Palisades Nuclear Plant
Operated by Nuclear Management Company, LLC

Palisades Nuclear Plant
Docket 50-255
License No. DPR-20

Response to NRC Requests for Additional Information Relating to License Renewal
dated October 24, 2005

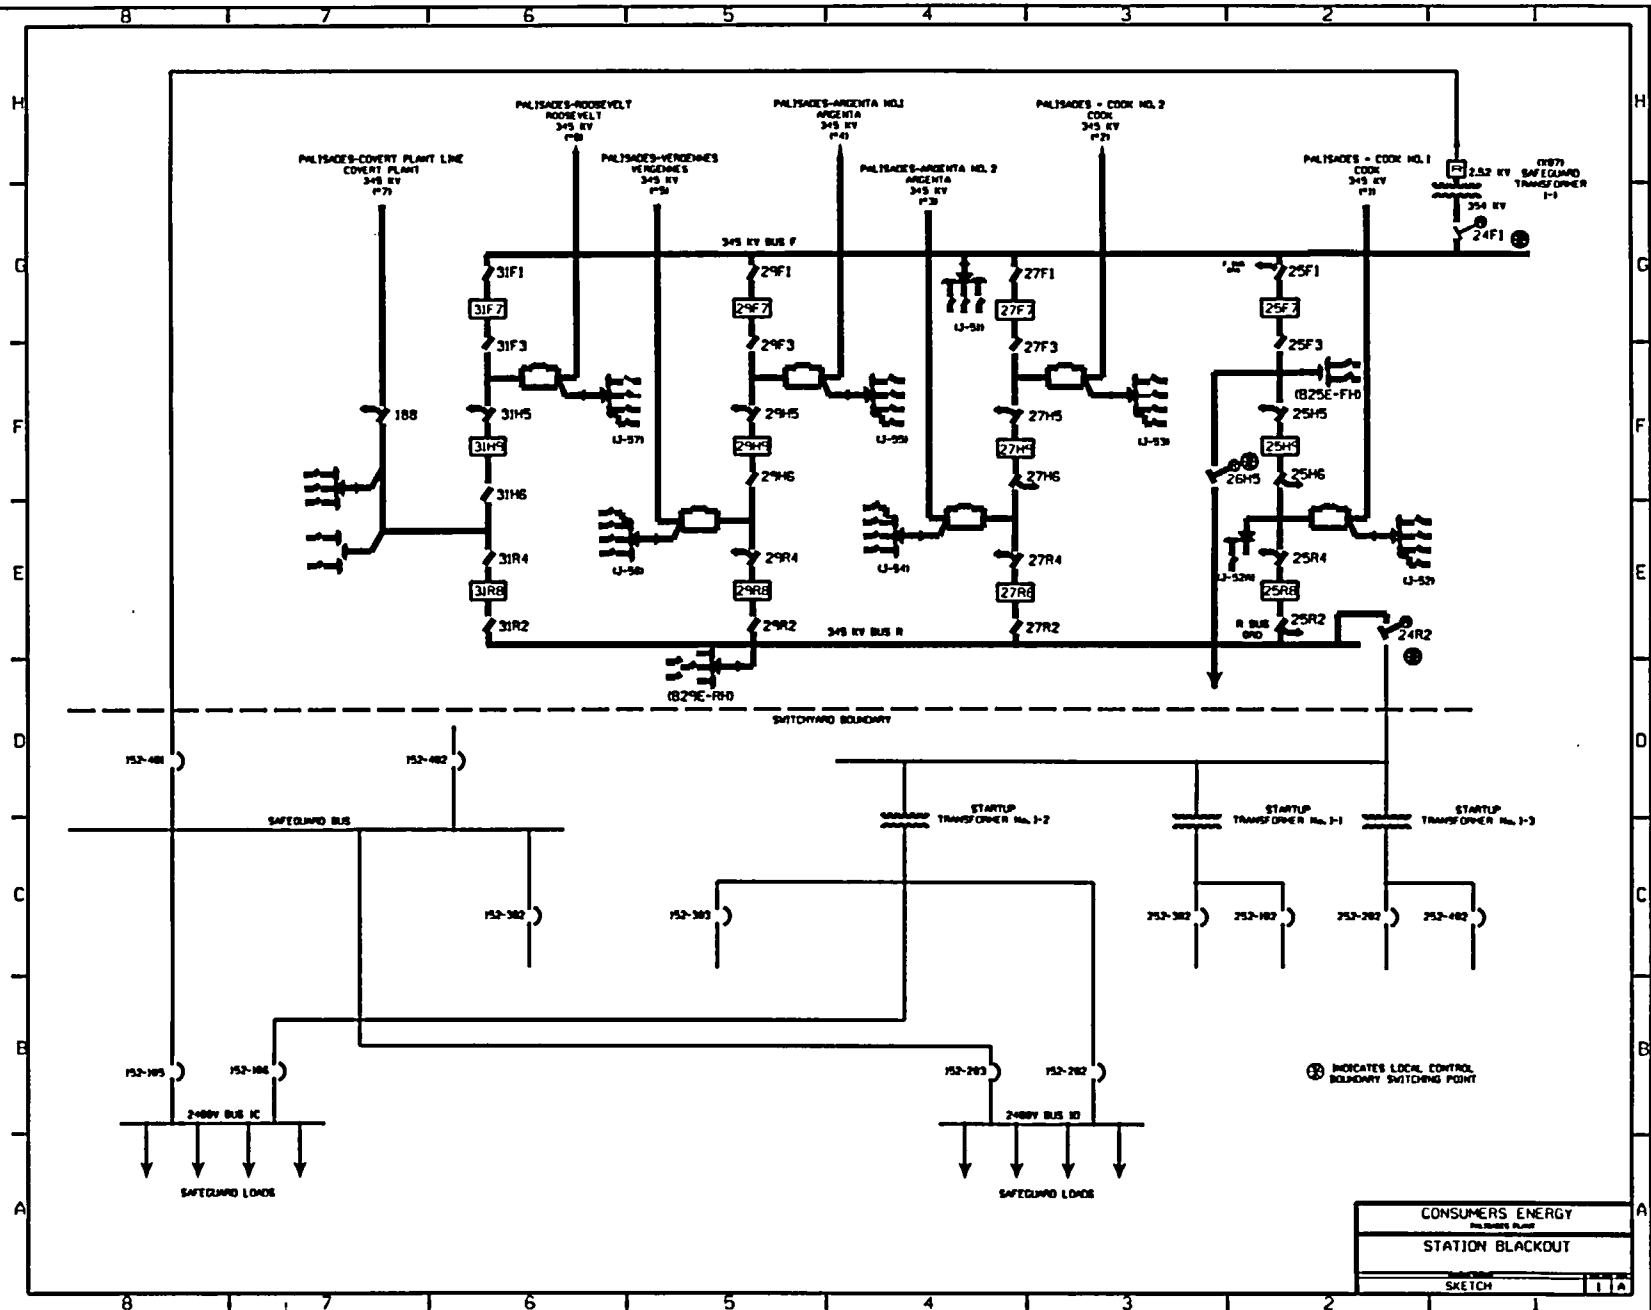
In Interim Staff Guidance-2 (ISG-2), the staff has determined that the plant system portion of the offsite power system that is used to connect the plant to the offsite power source should be included within the scope of the rule. This path typically includes the switchyard circuit breakers that connects to the offsite system power transformers (startup transformers), the transformer itself. In Section 2.5.9, you have provided license renewal boundaries of the switchyard. They included 345 kV Bus F, motor operated disconnect to the safeguard transformer and 345 kV Bus R and motor operated disconnect to the startup transformers.

- (a) Provide justification of not including the switchyard circuit breakers.
- (b) The 345 kV Bus F and R are not in scope for LR per Palisades Substation per drawing (LR-WD-1421-31). Clarify this discrepancy.
- (c) Revise the switchyard system function listing (SWY-01 to SWY-05) as appropriate.

The Palisades plant electrical distribution system connects to offsite power from the transmission system through several breakers that are individually operated to supply the desired plant bus(es). On the switchyard supply sides of these breakers is a transformer (Safeguard Transformer 1-1 or Startup Transformer 1-2) to step down the 345KV transmission system voltage to the 2400 VAC needed to supply the desired plant AC bus. The final connections between the primary sides of the transformers and the Palisades Switchyard F or R Buses are made via motor operated disconnects. The plant electrical distribution system is connected to or isolated from the transmission system with the breakers on the secondary (2400 VAC) side of the transformers. The motor operated disconnects on the primary sides are always closed unless they are deliberately opened (by local or remote manual operation) for maintenance; they are not operated to interrupt offsite power from, or restore offsite power to, plant systems. As shown on the Palisades drawings LR-WD-1421-31 and LR-WD-950 Sheet A, referenced in the LRA, these plant breakers are in scope for license renewal. In addition, the drawings also show that the upstream transformers and the motor operated disconnects have been included in scope. The transmission system and switchyard, including switchyard buses F and R which are used to interconnect the seven 345KV transmission lines that terminate in the switchyard, are not plant systems, and are not in scope of license renewal. The Palisades main generator output to the transmission system that connects between switchyard breakers 25F7 and 25H9, is also not in scope since backfeeding via that line is not credited for SBO recovery.

A simplified sketch of information extracted from LR-WD-1421-31 and LR-WD-950-A is included below to illustrate the boundary between the transmission system (including switchyard F and R buses) and the plant electrical systems. The transmission system is shown in black, and the two plant system connections from the transmission system in the switchyard to the plant electrical distribution buses, which are in scope of license renewal, are shown in red.
